| Project | ADELAIDE CENTRAL PLA |
| SKS No. | J1301-STR-SKT-0001 |
| Sketch | STRUCTURAL CONCEPT SKETCHES |

| Project | Drawing | Date | Issue |
|---|---|---|---|
| Adelaide Central Plaza Tower - Premium A-Grade Commercial | 24176 - DR-02-01 | 14.03.25 | Prelim - Issue 05 - For Co-ordination |

# SECOND FLOOR LINK PLAN

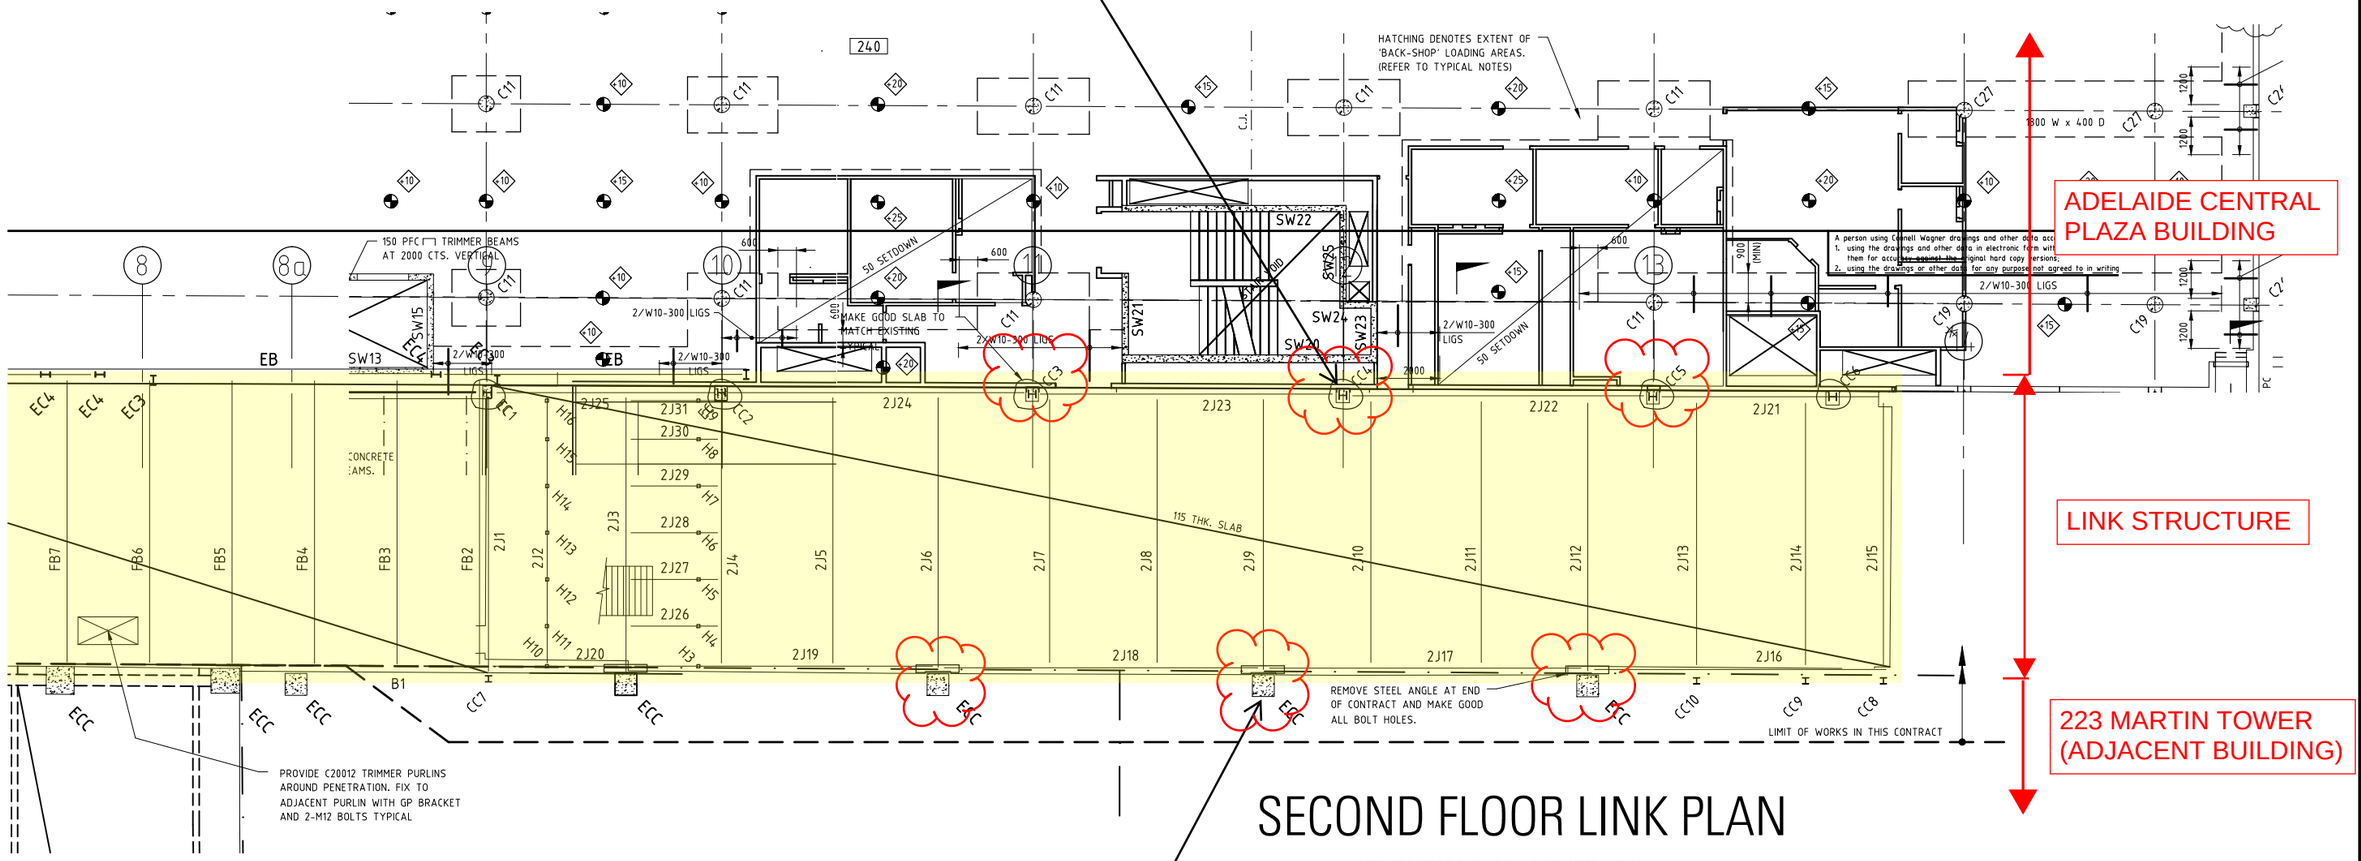
CONNECTION FIXED TO BUILDING AT THIS SIDE ON L2.

SLIDING CONNECTION ASSUMED TO 2223 MARTIN TOWER BUILDING. FURTHER INVESTIGATION AND ASSESSMENT OF NEIGHBOURING BUILDING REQUIRED.

# SECOND FLOOR LINK PLAN

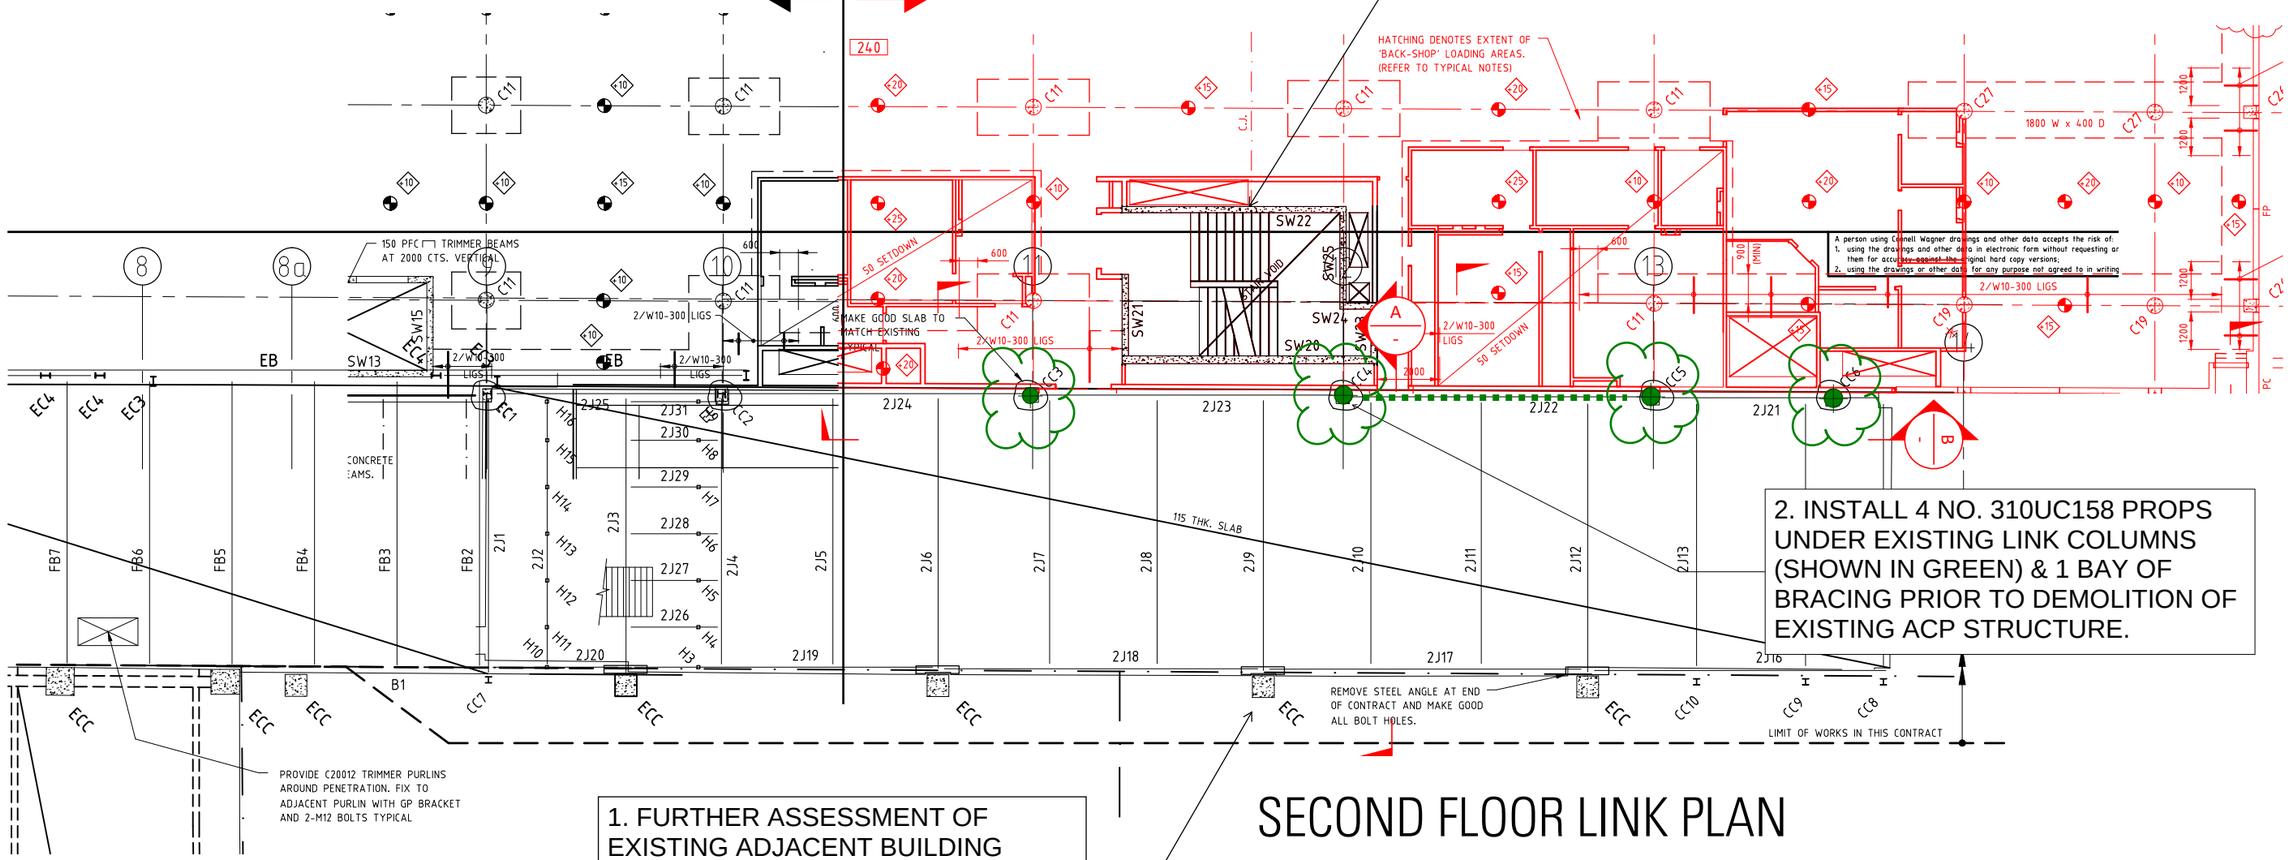
CAREFUL DEMOLITION OF BUILDING STRUCTURE AROUND BRIDGE REQUIRED.
PROPS TO BE INSTALLED PRIOR TO ANY DEMOLITION WORKS TAKING PLACE

CLADDING TO UNDERSIDE OF BRIDGE. PARTIAL REMOVAL REQUIRED DURING CONSTRUCTION OF ACP TO INSTALL TEMPORARY PROPS

FURTHER ASSESSMENT OF NEIGHBOURING BUILDING REQUIRED TO DETERMINE IF LINK STRUCTURE CAN BE BRACED TO STRUCTURE IN THE TEMPORARY CASE DURING DEMOLITION WORKS.

SECTON A

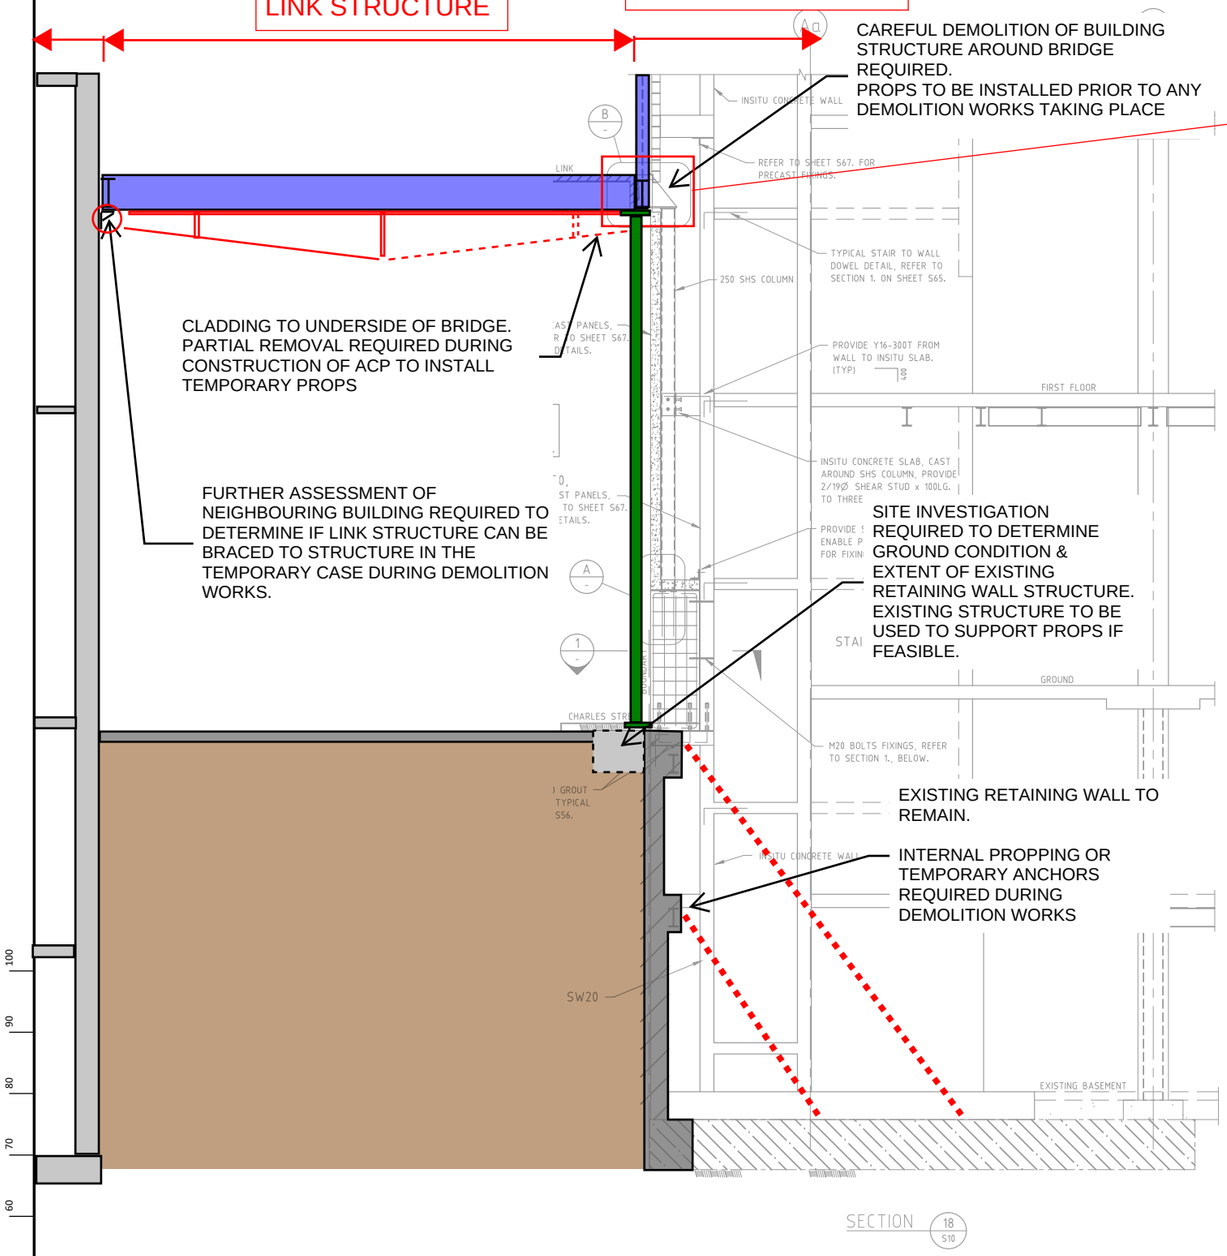
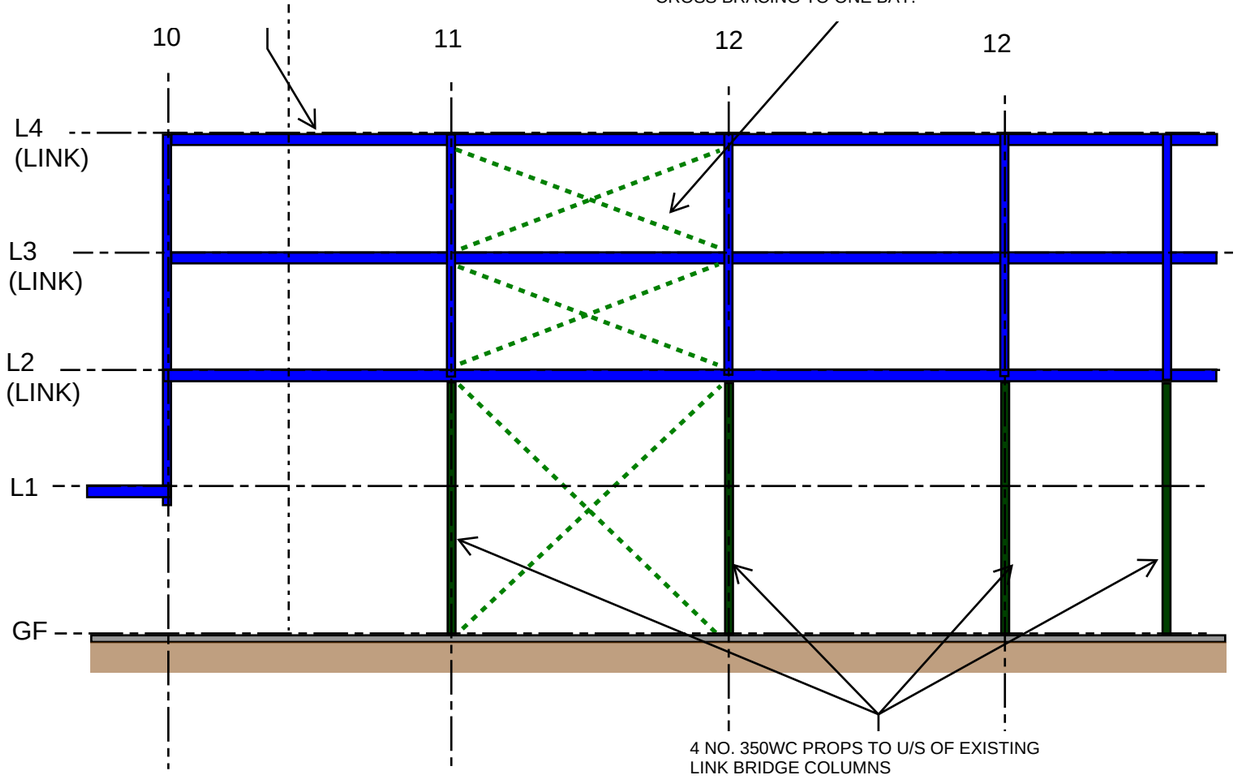
SITE INVESTIGATION REQUIRED TO DETERMINE GROUND CONDITION & EXTENT OF EXISTING RETAINING WALL STRUCTURE. EXISTING STRUCTURE TO BE USED TO SUPPORT PROPS IF FEASIBLE.

EXISTING RETAINING WALL TO REMAIN.

INTERNAL PROPPING OR TEMPORARY ANCHORS REQUIRED DURING DEMOLITION WORKS

CROSS BRACING TO ONE BAY.
